Rules and transitional periods for specific requirements complementary to the technical guideline:

Generating plants connected to the medium-voltage network - Guideline for generating plants' connection to and parallel operation with the medium-voltage network

Effective from 1st January 2013

Figure 4: Correlation between protective disconnection-intrinsic protection capacity of the plant

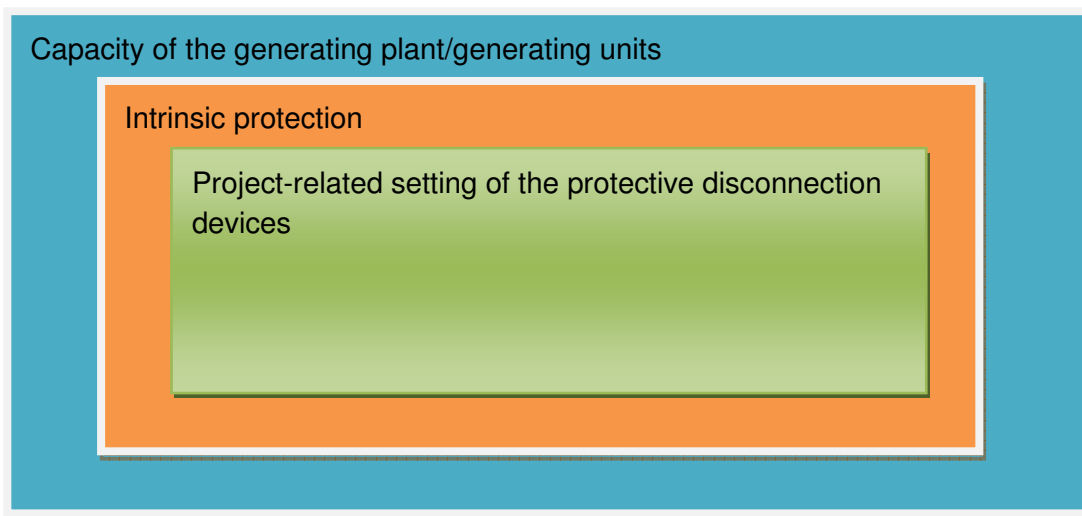
Figure 4 below represents the correlation between:

- setting of the protective disconnection device,
- intrinsic protection and
- capacity of the generating plant/generating units.

The BDEW Guideline on „Generating plants connected to the medium-voltage network“ does not contain any requirements in terms of dynamic network support above 110 % U_c . This 4th supplement does not define any new requirements for dynamic network support outside the voltage range of $\pm 10\%$ U_c , the existing rules shall thus remain unchanged.
